North Campus Faculty Housing Phase II  
Project No. FM110407L/986315

**Addendum No. 6**

ADDENDUM NUMBER 6  
to the  
CONSTRUCTION DOCUMENTS

BUILDING 700A : SECTIONS 2

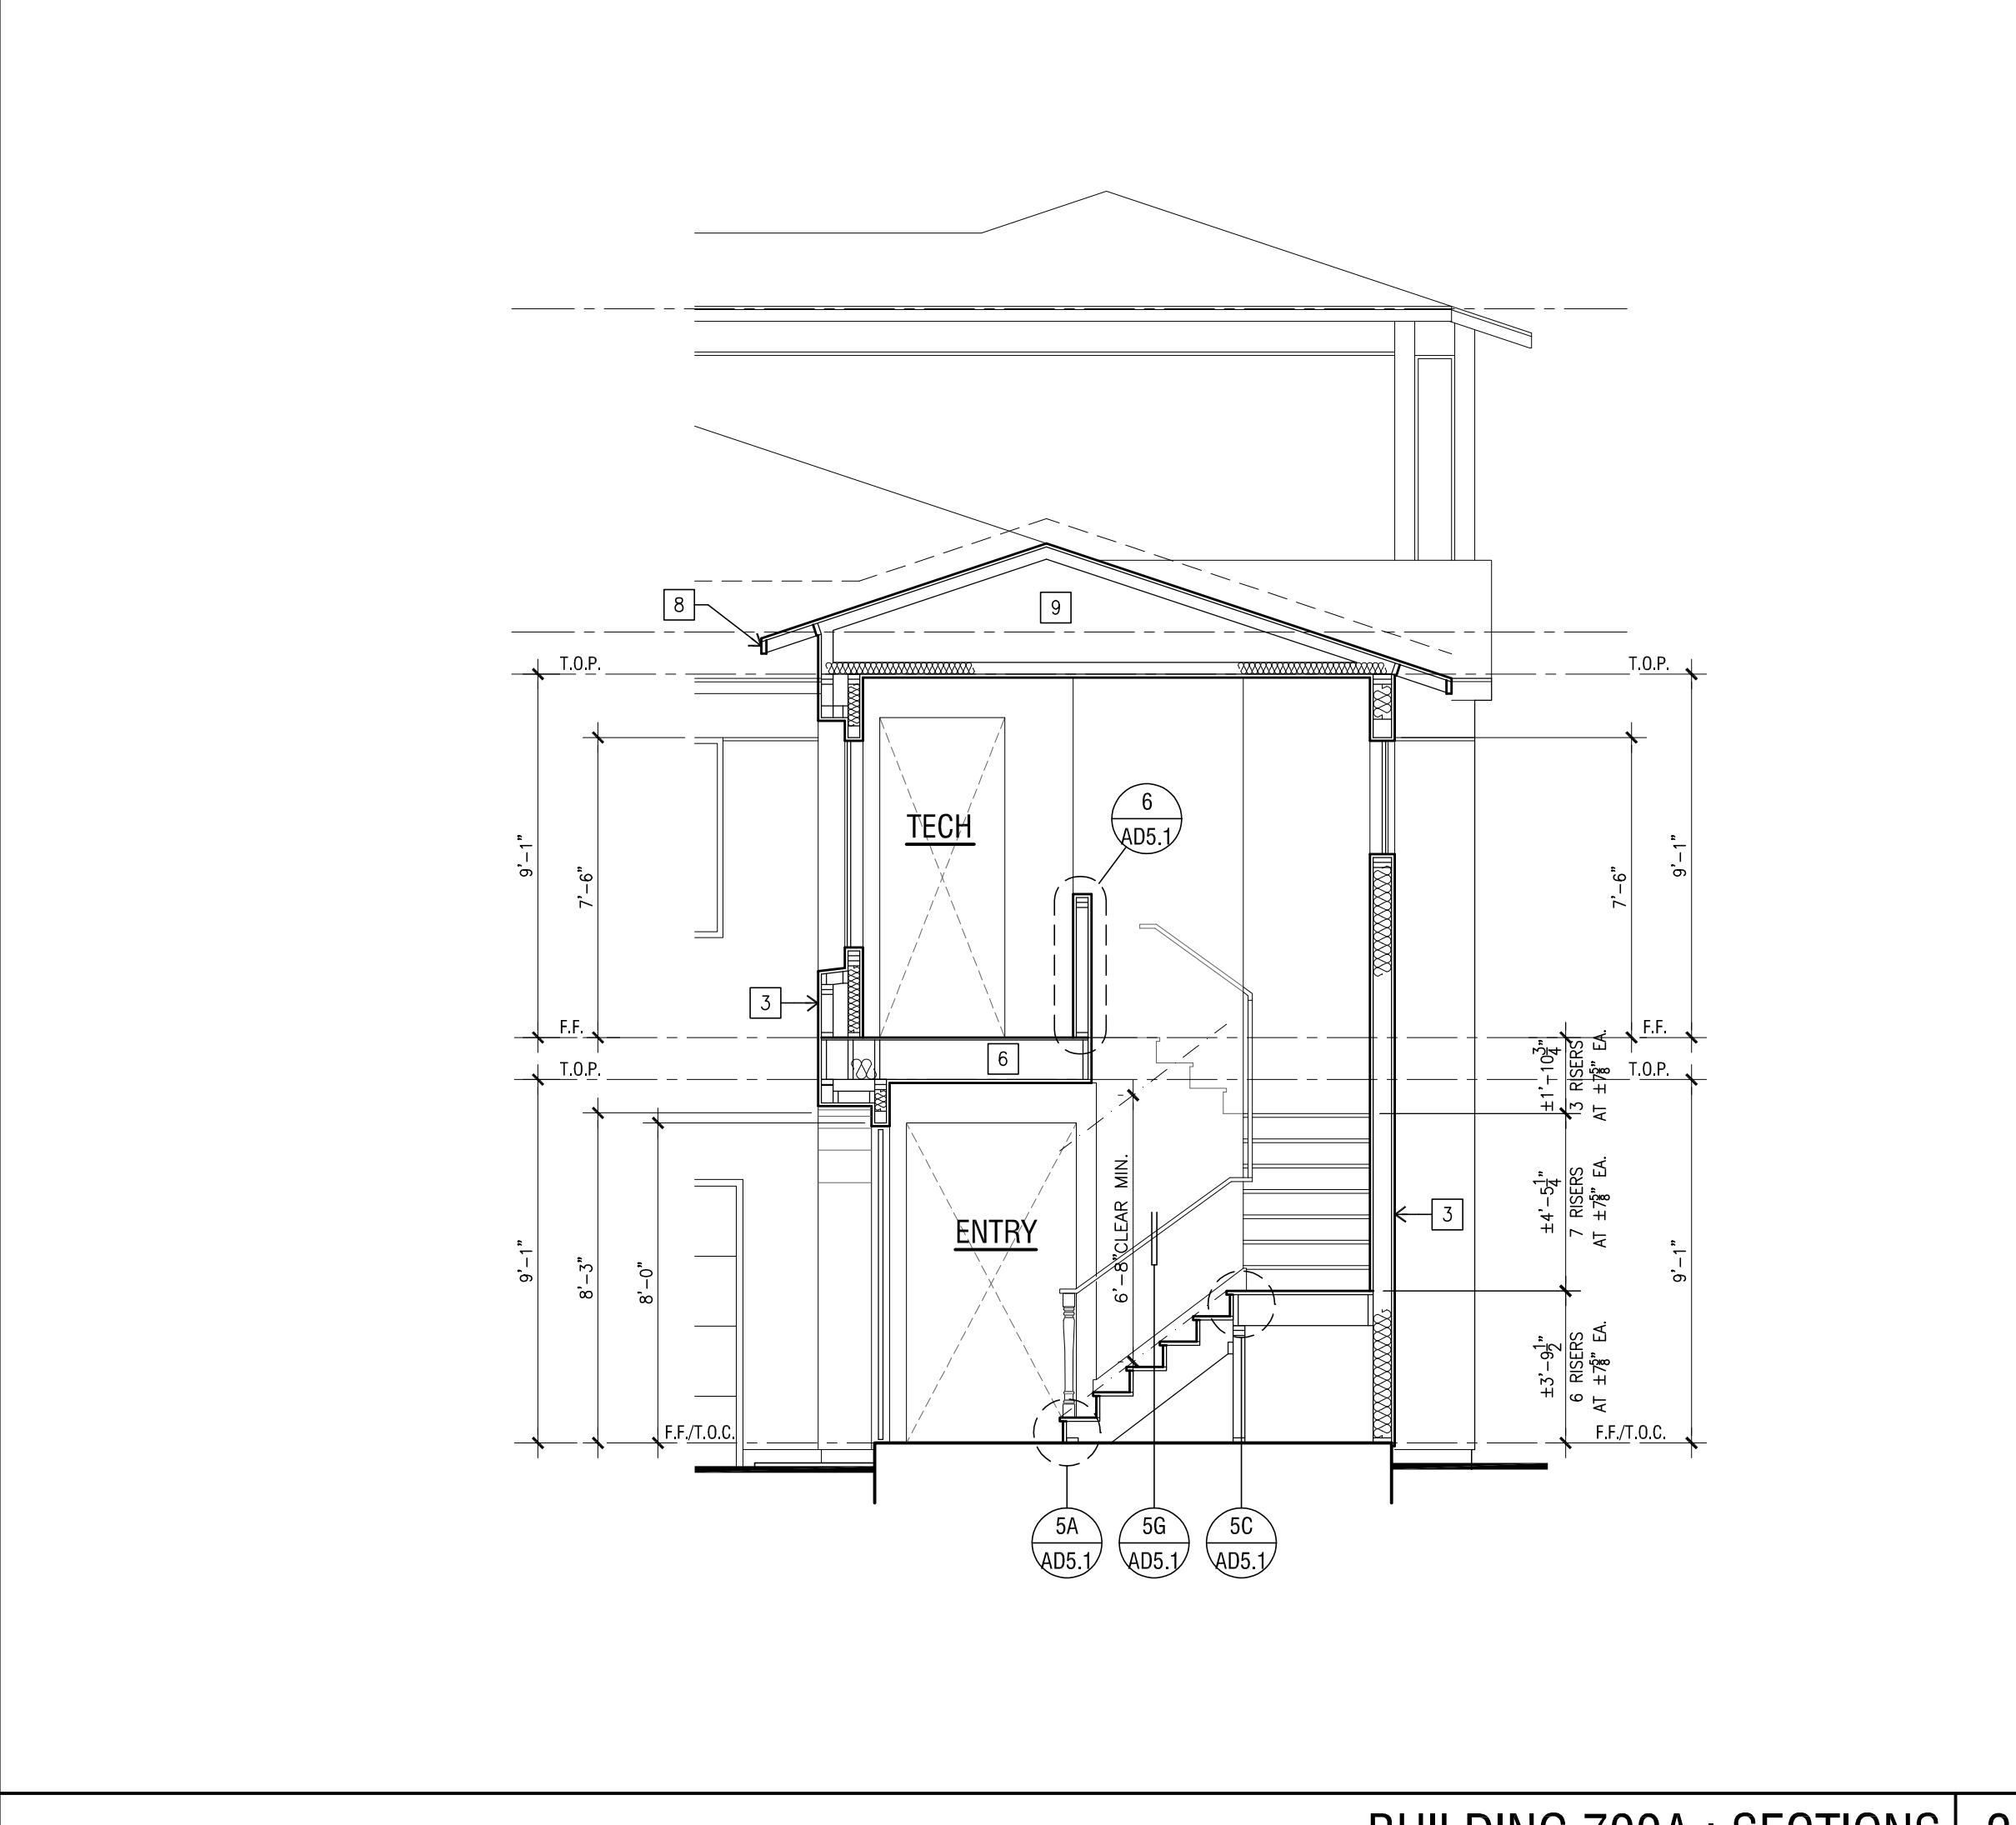
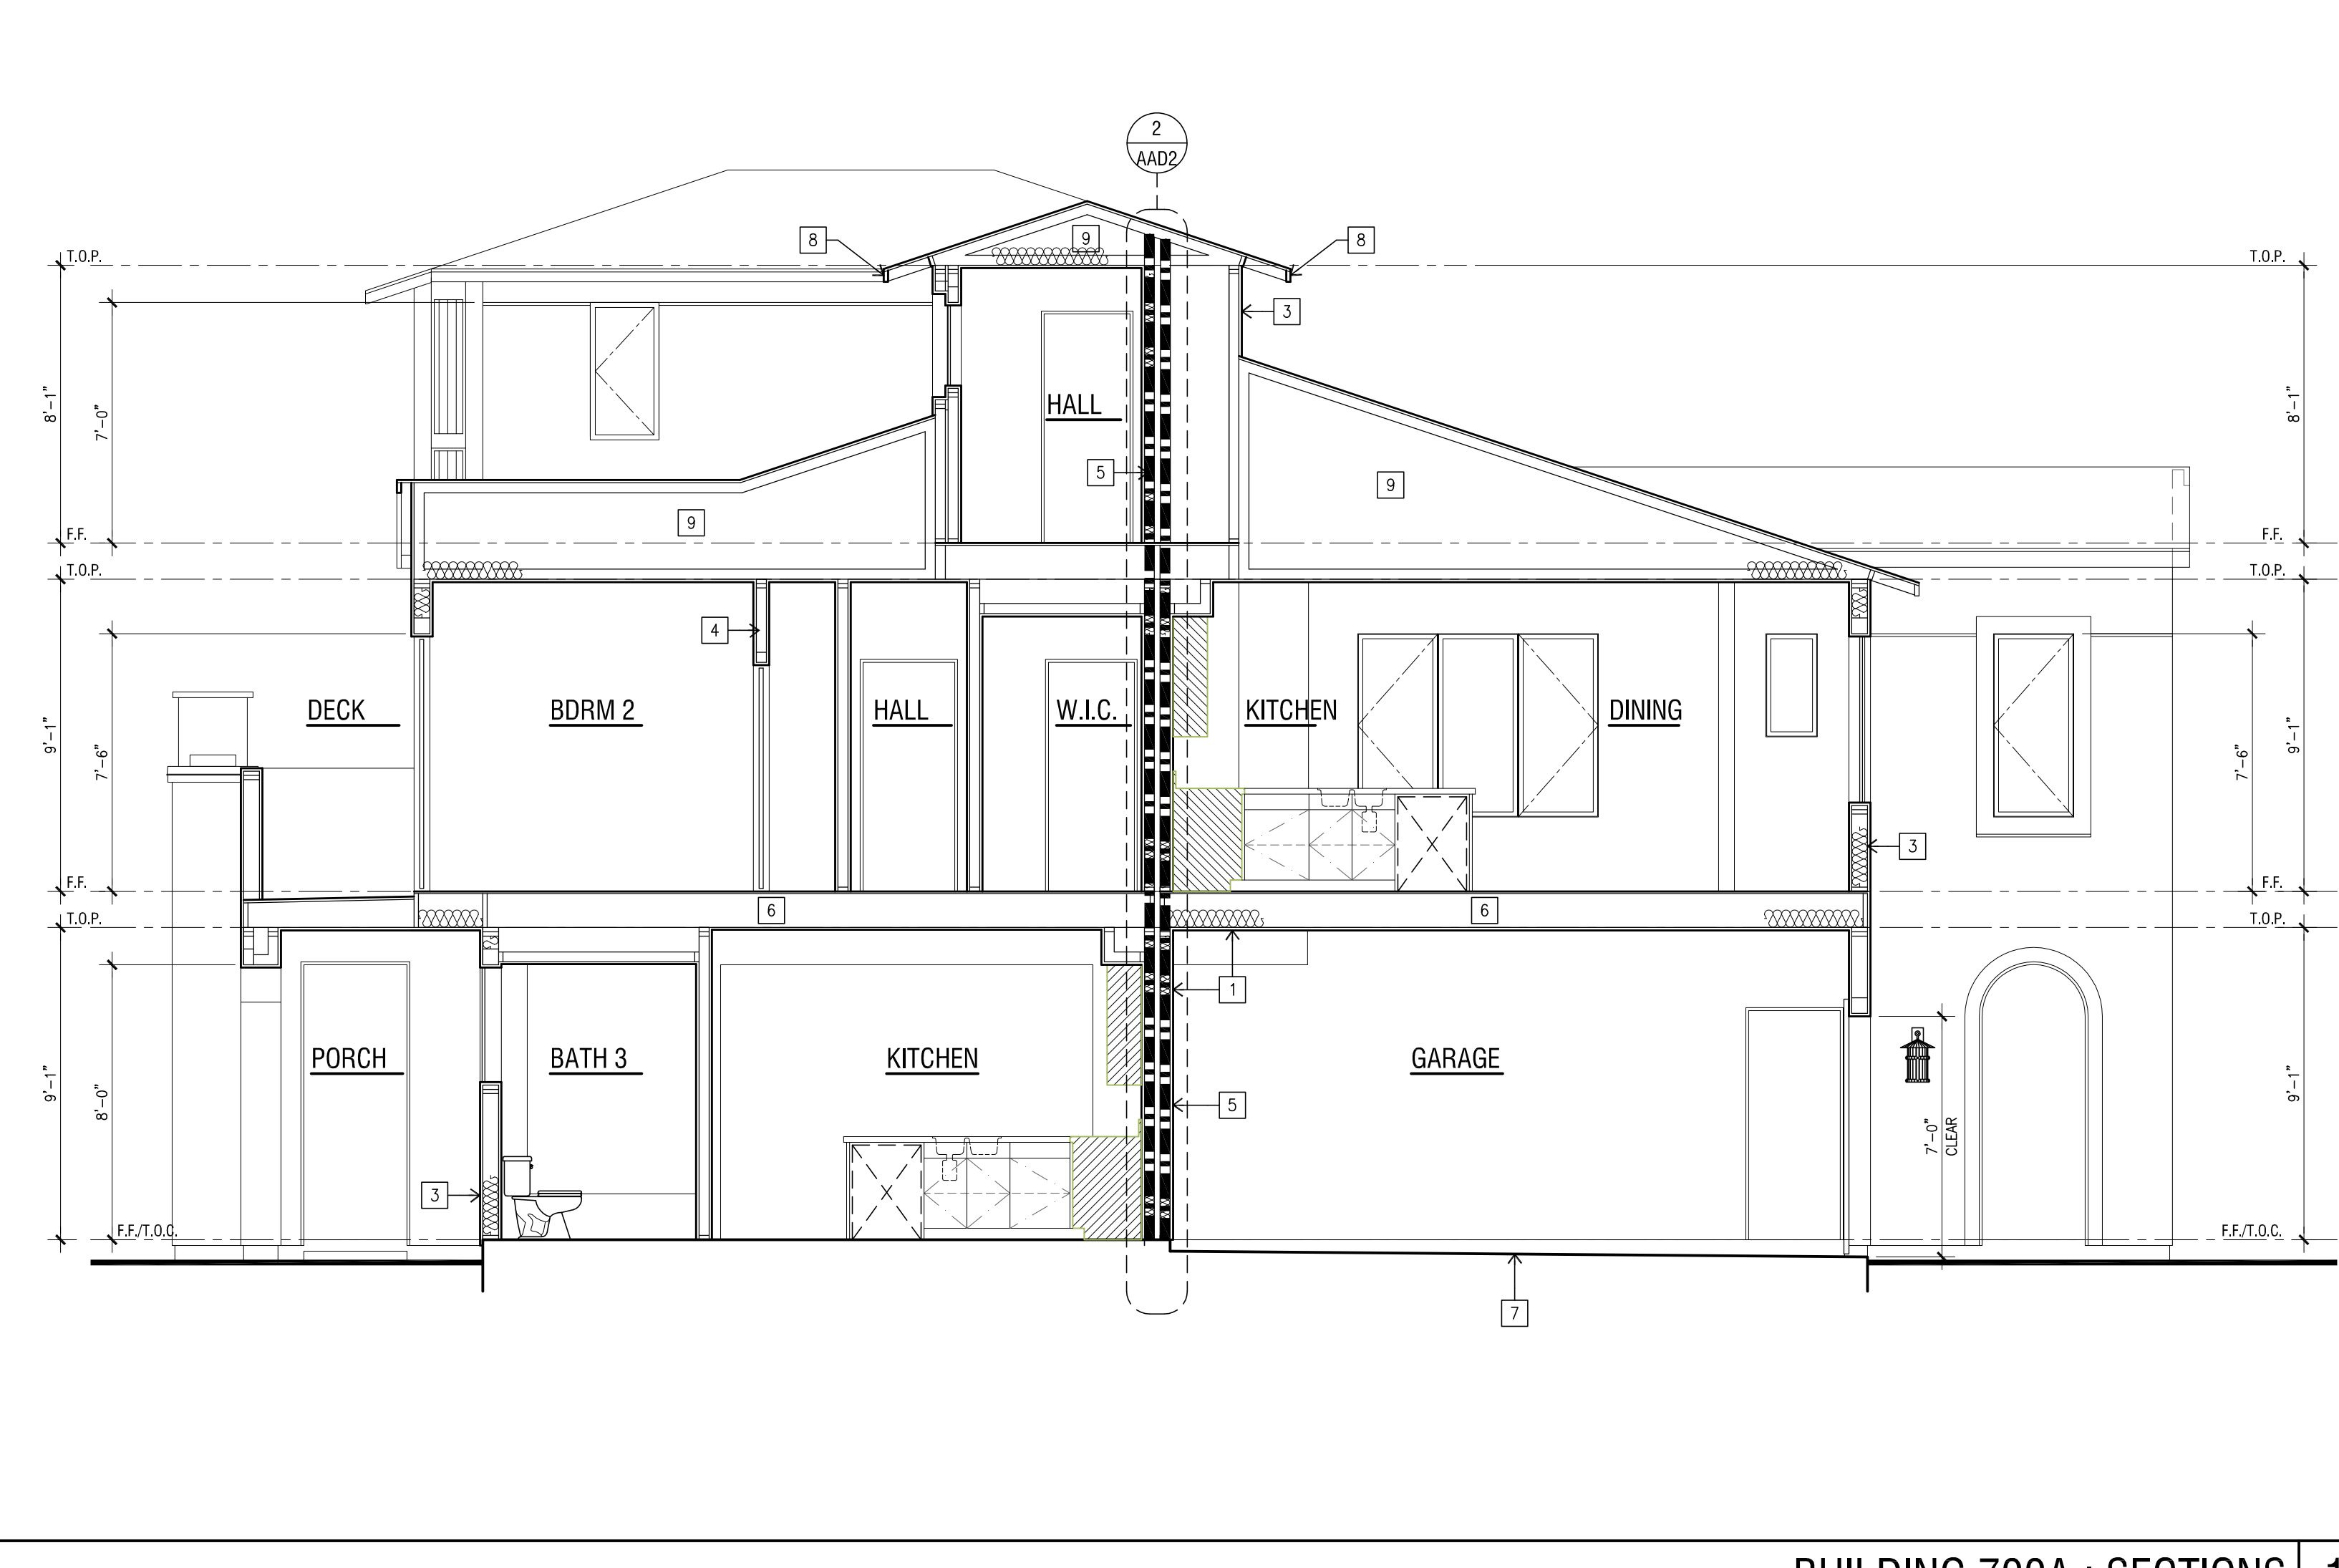
Sketch 5 of 8	Building 600A: Reverse: Sections
Sketch 6 of 8	Building 600B: Sections
Sketch 7 of 8	Building 700A: Sections
Sketch 8 of 8	Building 700A: Reverse: Sections
